To: Brookline Planning Board
From: Brookline Planning Department staff
Date: November 3, 2016
Subject: Construct retaining walls in side and rear yards
Location: **47 Craftsland Road (continued)**

Atlas Sheet:	121	Case #:	ZBA #2015-0037
Block:	423	Zoning:	S-7
Lots:	12 and 13	Lot Area (s.f.):	±15,331 sf

PLANNING BOARD COMMENTS

47 Craftsland Road
 Brookline, Massachusetts
Proposed Drainage and Grading - Permit Plan
 Scale: 1"=20' May 11, 2015
VERNE T. PORTER Jr., PLS
 Land Surveyors - Civil Engineers
 354 Elliot Street Newton, Massachusetts 02464

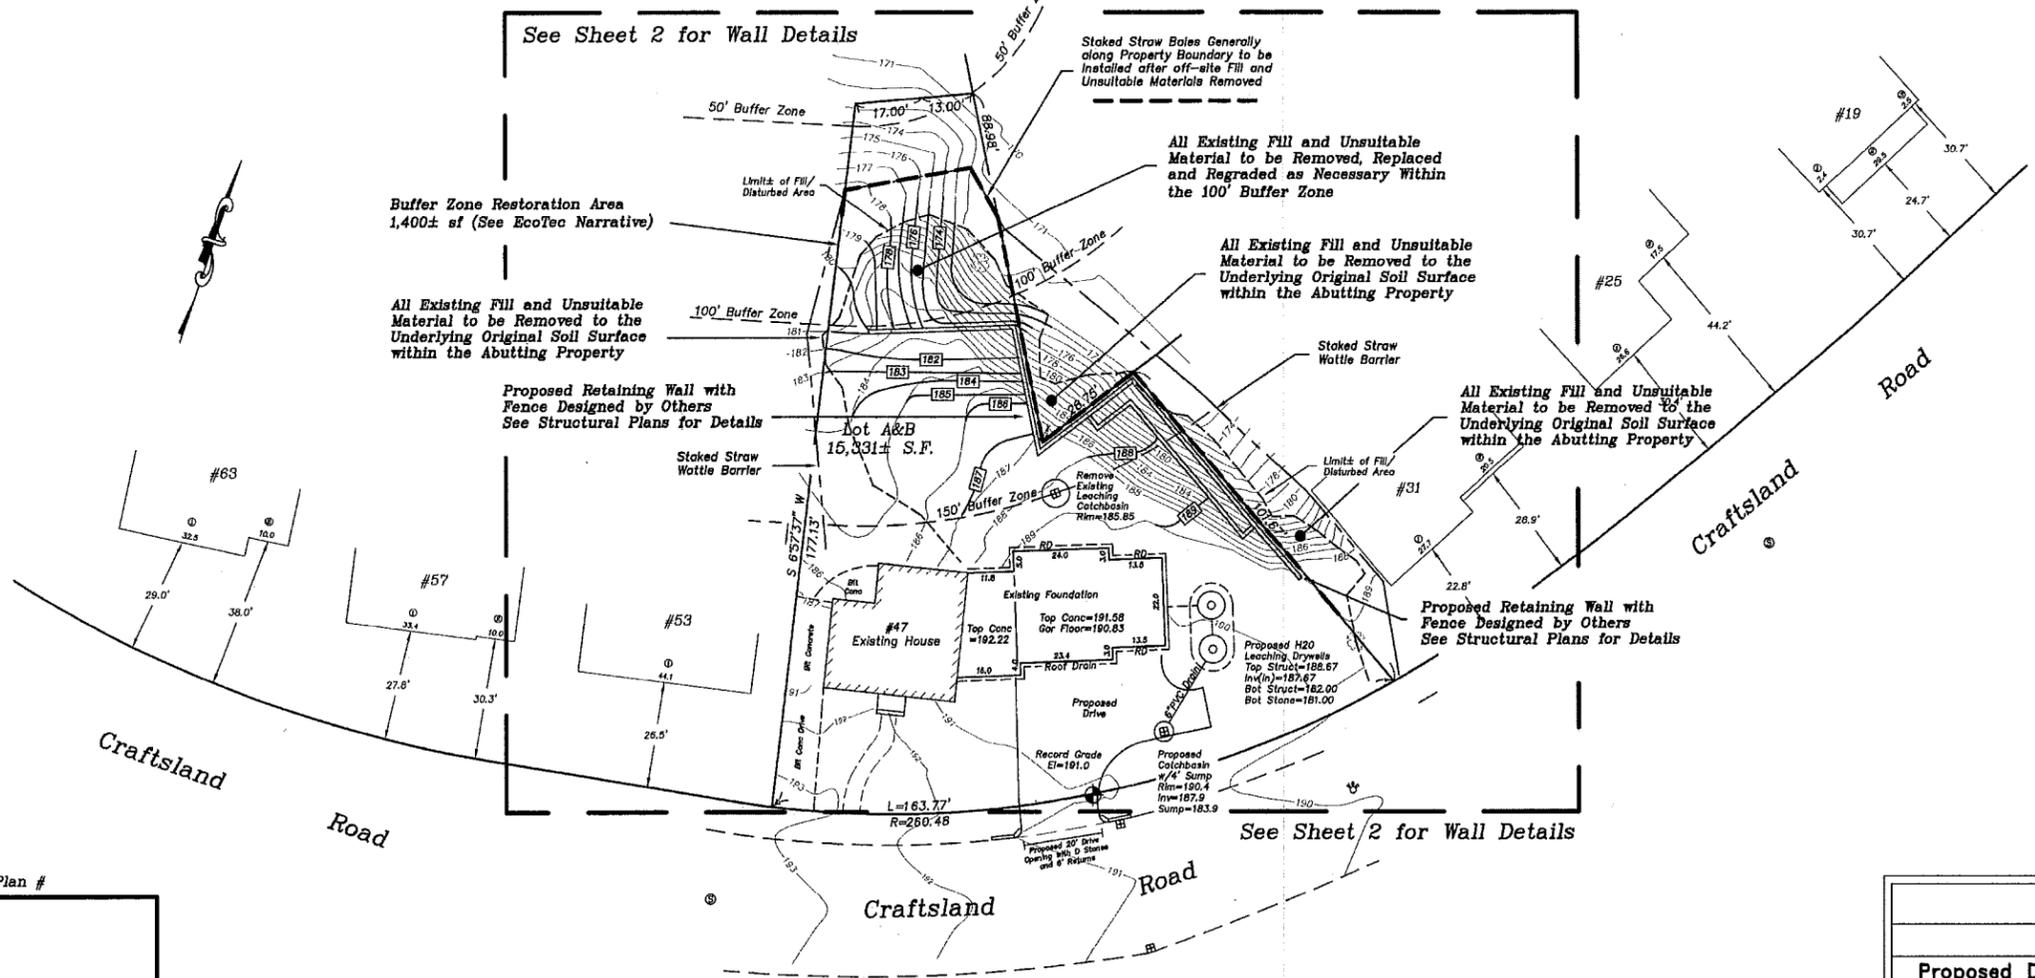
The originally proposed wall was found by the Planning Board to be too high, overly institutional and in full view of the side abutter. A tiered wall design was recommended. On September 30, 2015, the applicant and his attorney met with staff from the Building, Planning, Transportation & Engineering, and Conservation to discuss alternatives that would accommodate a tiered design. The newly revised design adheres to the staff recommendations.

Therefore, the Planning Board recommends approval of the proposal and plans, including the site plan prepared by registered land surveyor Verne T. Porter and revised August 26, 2016 and elevations by registered architect David O’Sullivan revised September 7, 2016.

1. Prior to the issuance of a building permit, the applicant shall submit final plans, including grading and a wall section, and elevations of the wall stamped and signed by a registered land surveyor or engineer, subject to the review and approval of the Assistant Director of Regulatory Planning and the Director of Engineering.

2. Prior to the issuance of a building permit, the applicant shall submit to the Assistant Planning Director and Building Commissioner a pre-construction affidavit that a registered engineer shall oversee the construction of the wall, including verifying the location of the footings as complying with the property line and shall submit an affidavit at the end of construction that the wall conforms to standard engineering practice.
